Project Name: 131 SE 7th Avenue (2020-159)

Request: Certificate of Appropriateness

HISTORIC PRESERVATION BOARD STAFF REPORT

131 SE 7th Avenue

A1.1

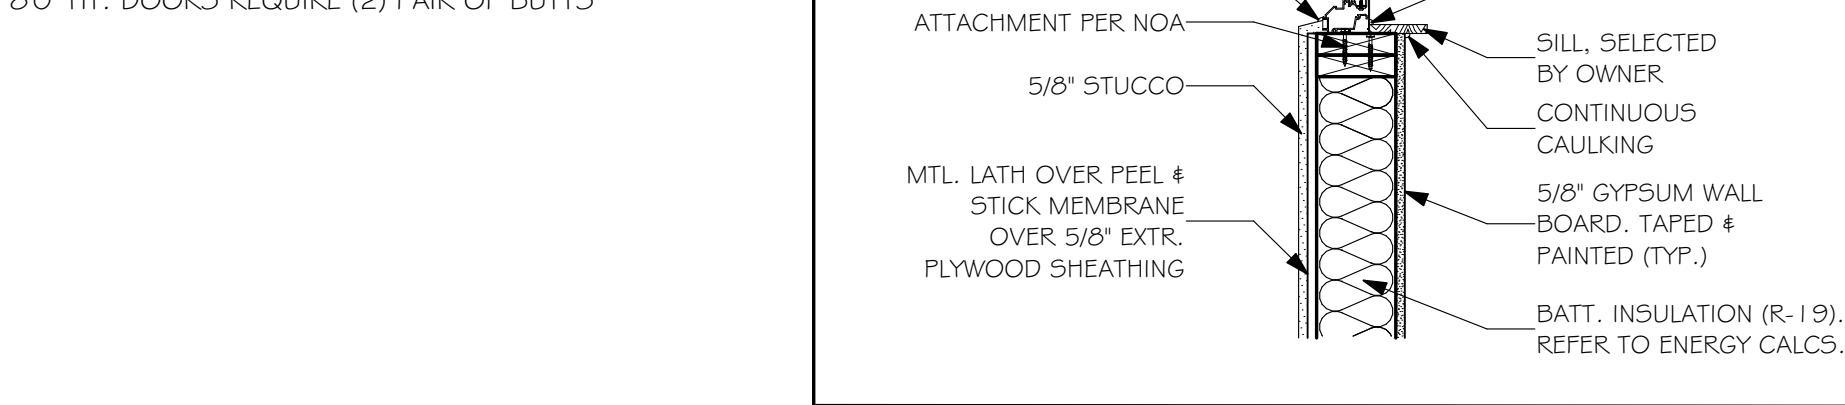
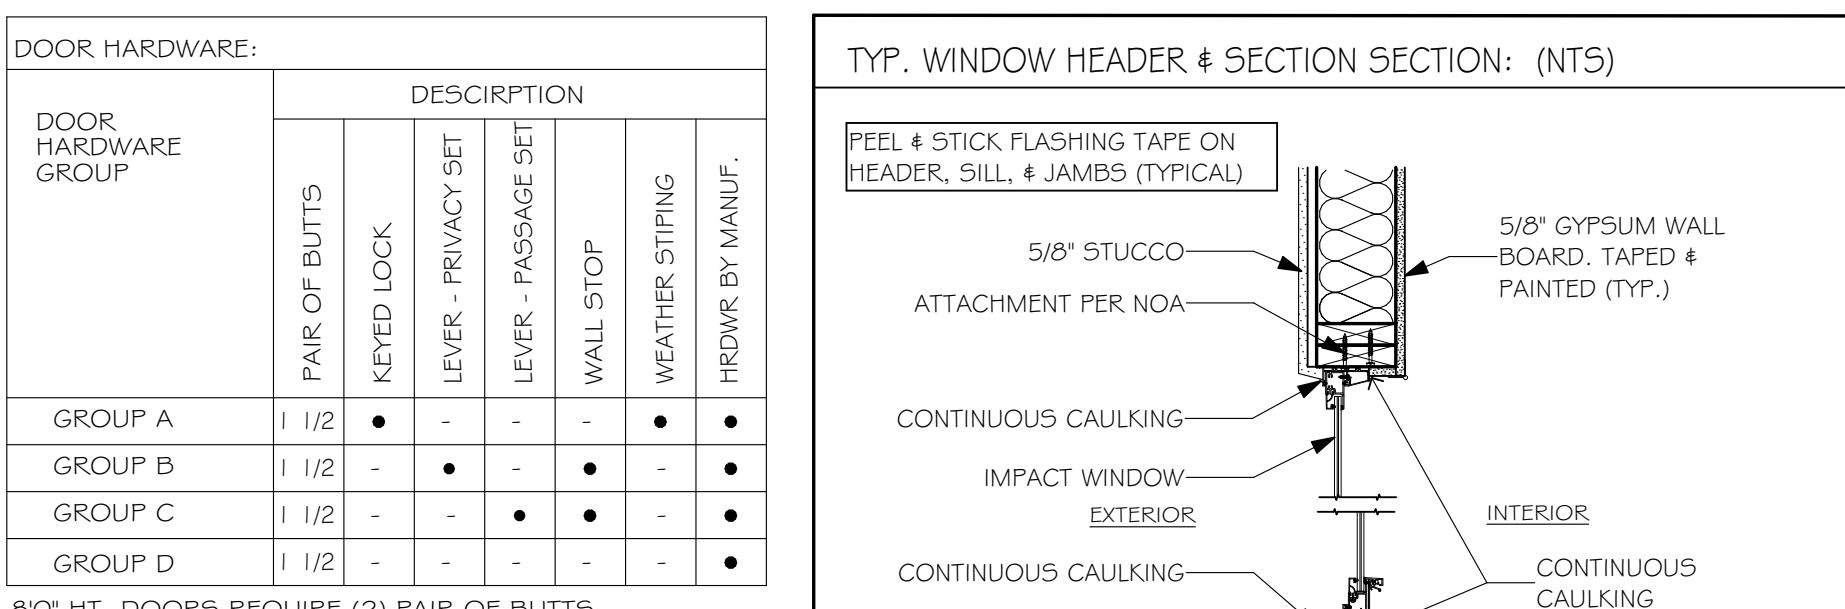
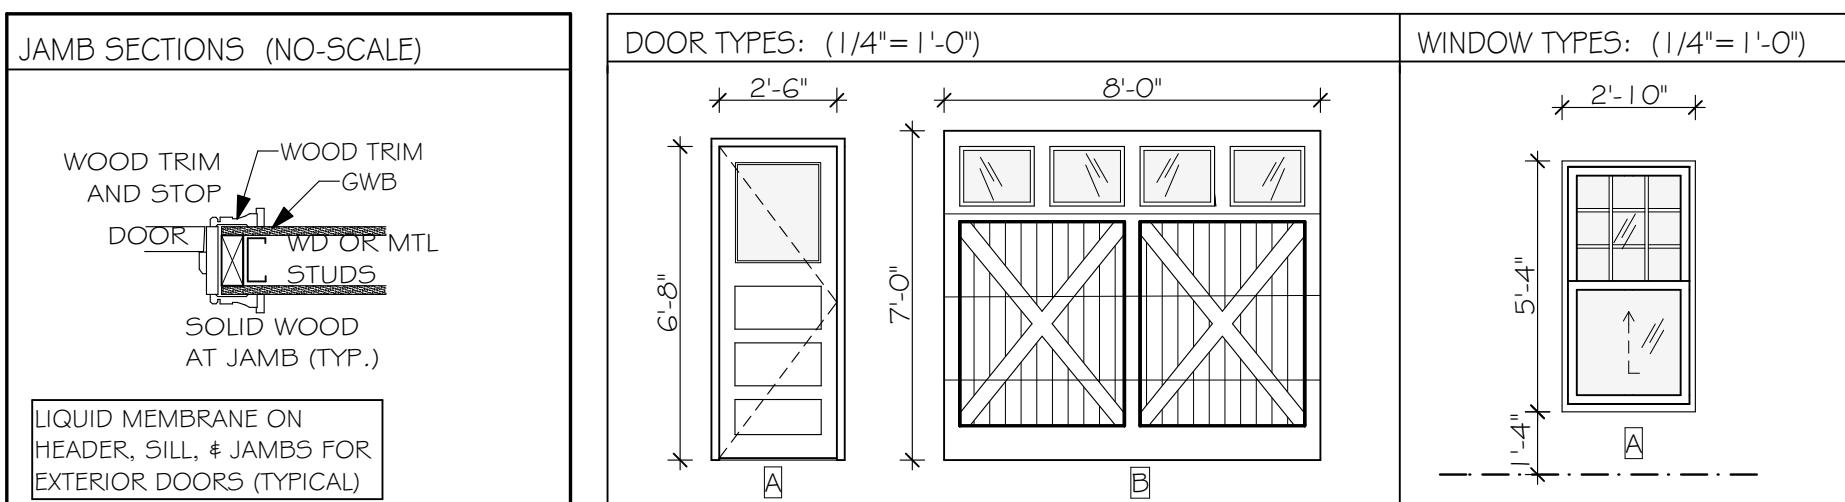
Also, proposed are new single-hung 1-over-1 windows on the west, south, and north elevations. The proposed windows are wood frame and single-hung. In February 2020, the HPB approved a window replacement for the residence to include white, aluminum framed, single-hung windows with a 9-over-1 dimensional muntin pattern. The glass was approved as clear. Added Site Plan Technical items approval are: that the proposed garage windows match those approved for the residence, in that they be white framed, single-hung, with clear glass, and a 9-over-1 dimensional muntin pattern;

and, that the window schedule on plan sheet A1.1 and the elevation drawings on plan sheet A2.1 be updated to reflect such details.

- 1. That the required and proposed pool setbacks be indicated on the Site Data chart on plan sheet SP1.1
- 2. That the proposed open space calculation indicated on the Site Data chart on SP1.1 be updated to reflect the proposed pool.
- 3. That the proposed garage windows match those approved for the residence, in that they be white framed, single-hung, with clear glass, and a 9-over-1 dimensional muntin pattern; and,
- 4. That the window schedule on plan sheet A1.1 and the elevation drawings on plan sheet A2.1 be updated to reflect the details of proposed windows.

A2.1

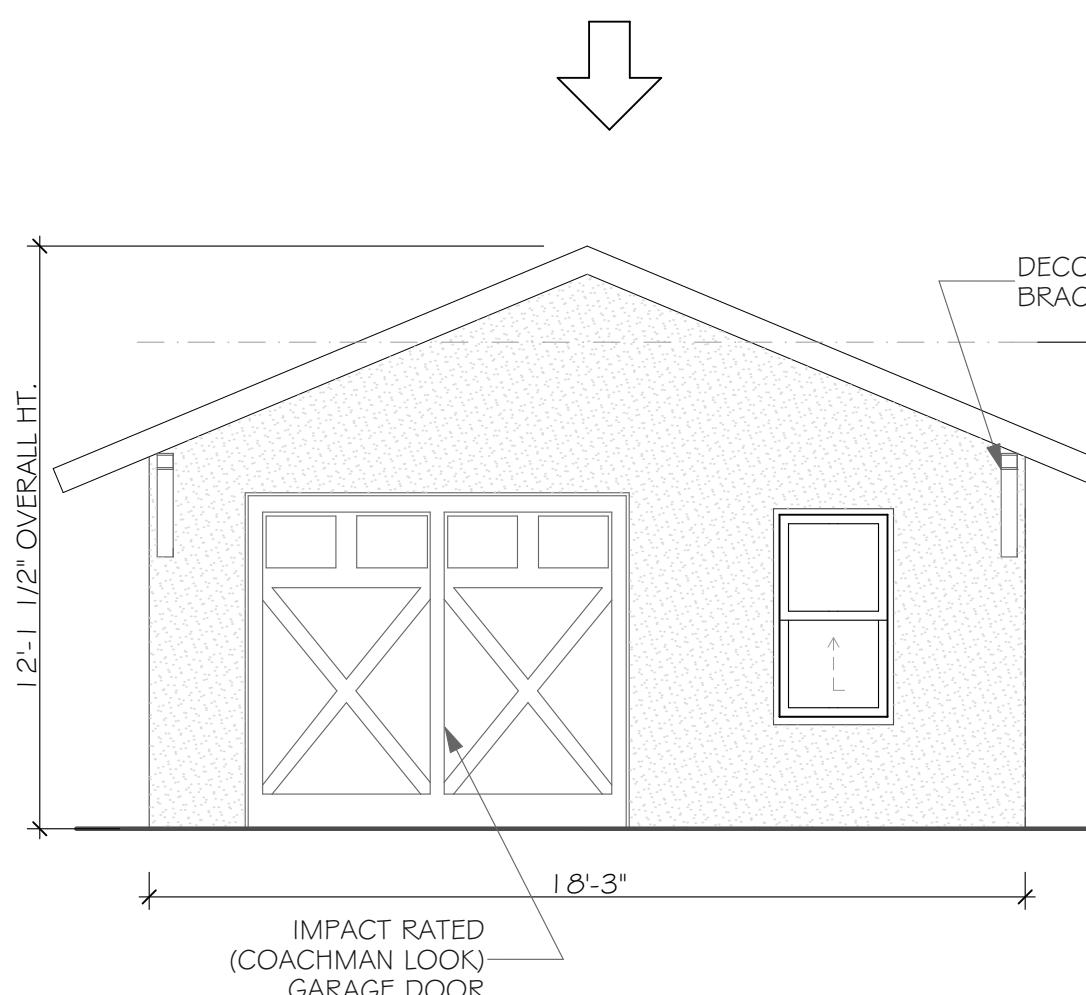
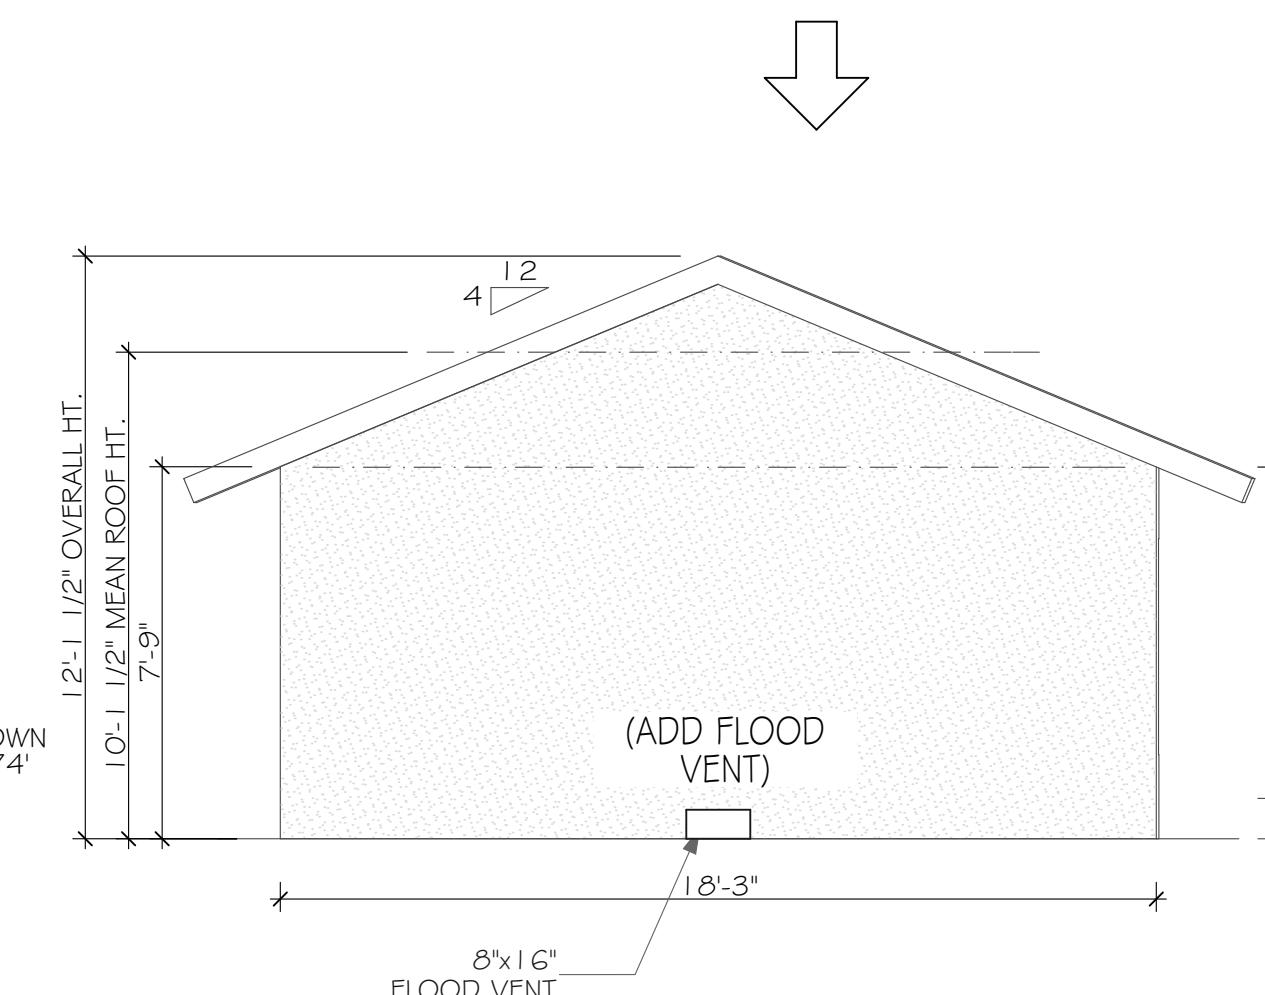
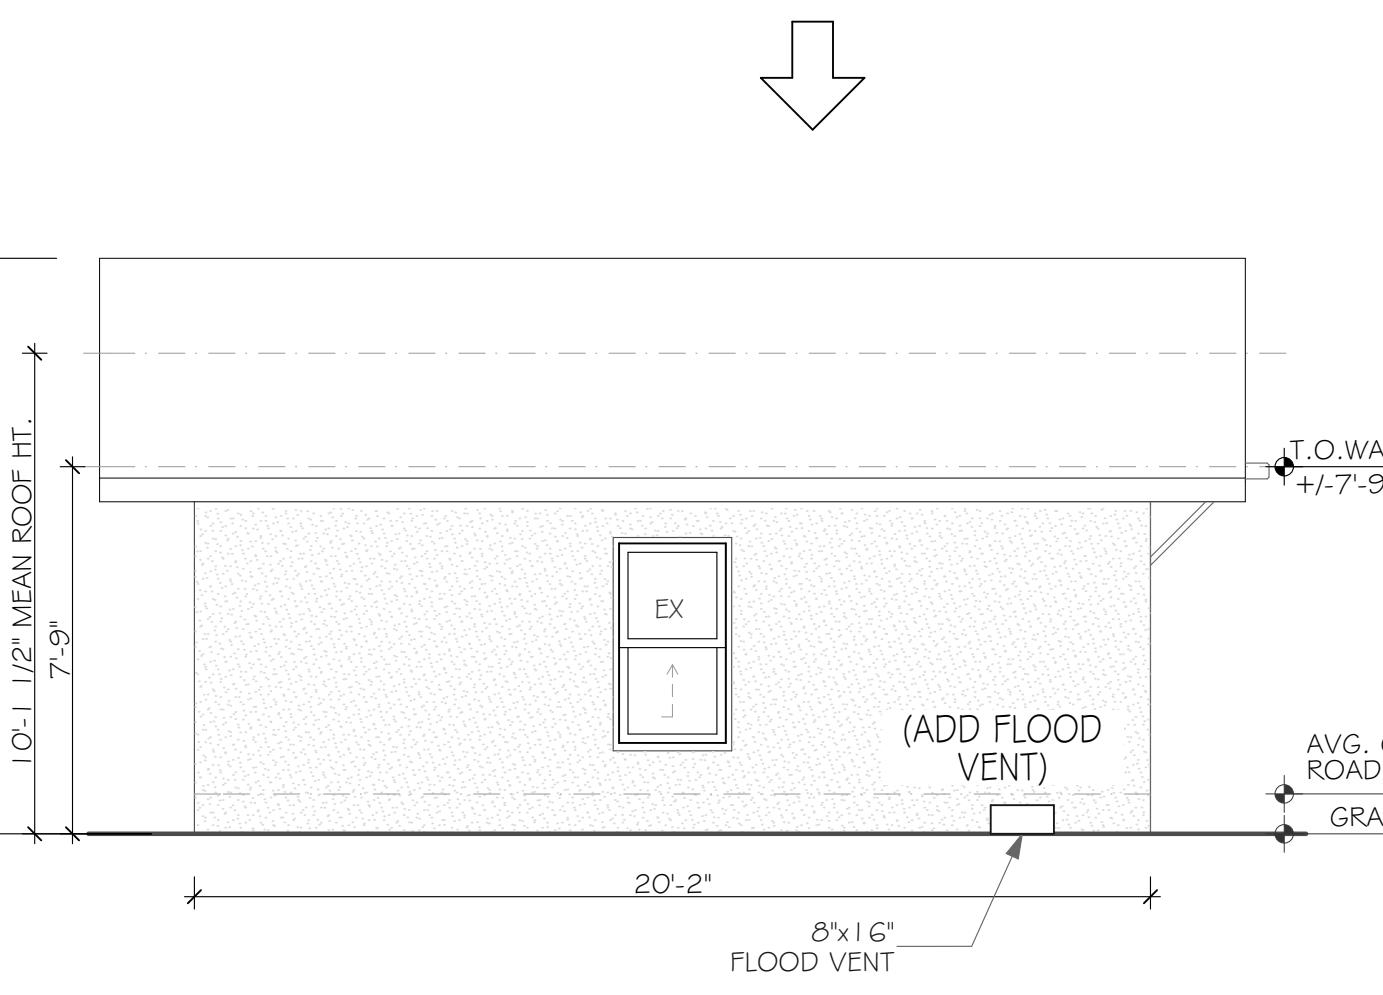
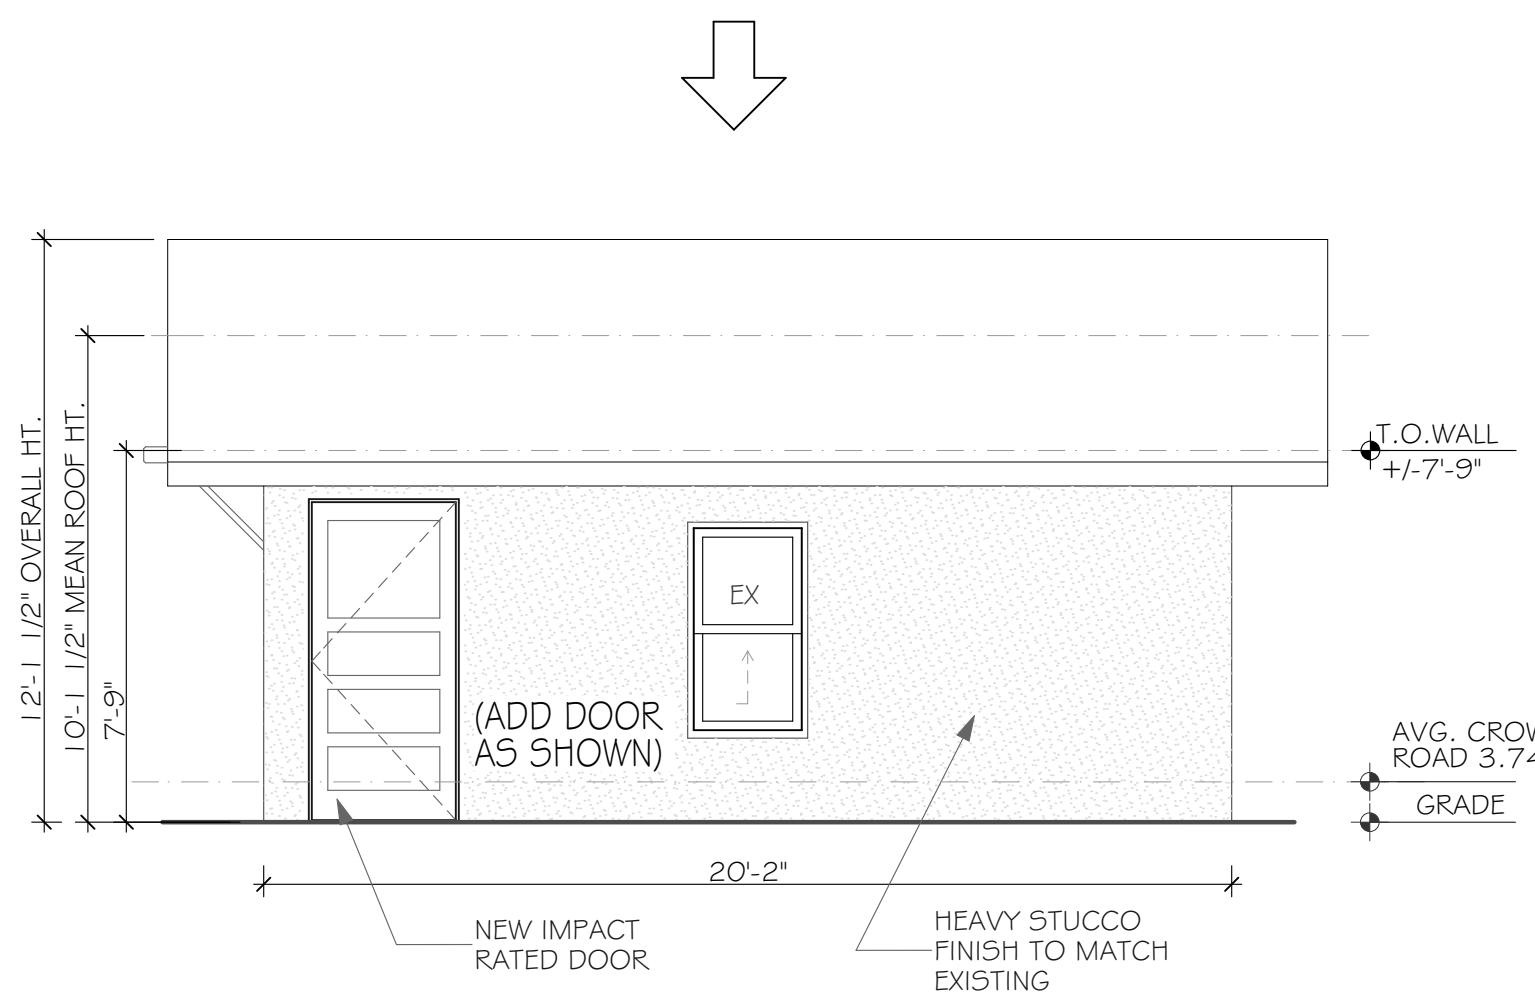
The existing garage is simple and rectangular in form with a gable roof and 2-car garage door. It is believed that the structure may have been altered from its original form due to the existing size of the 2-car garage metal door opening. The west (front) elevation will feature a single 9' wide cottage style, steel garage door with the installation of a new 1-over-1 single-hung window. In addition, a single man door in the same style is proposed on the south elevation and new single-hung 1-over-1 windows are proposed on the south and north elevations. The proposed windows are wood frame and single-hung. In February 2020, the HPB approved a window replacement for the residence to include white, aluminum framed, single-hung windows with a 9-over-1 dimensional muntin pattern. The glass was approved as clear. Added Site Plan Technical items approval are: that the proposed garage windows match those approved for the residence, in that they be white framed, single-hung, with clear glass, and a 9-over-1 dimensional muntin pattern; and, that the window schedule on plan sheet A1.1 and the elevation drawings on plan sheet A2.1 be updated to reflect such details.

In relation to the Proportion of Openings (windows and doors), the existing 16' steel, 2-car garage door is proposed to be replaced by a 9' wood garage door and a single-hung, aluminum, impact-rated window. As a contributing structure, it is an appropriate preservation practice to restore openings to their original size and style as the larger opening that currently exists on the front façade does not fit with the time frame that the structure was originally built. The south side of the garage also proposes to include a 36" door as an alternative way to enter through the garage.
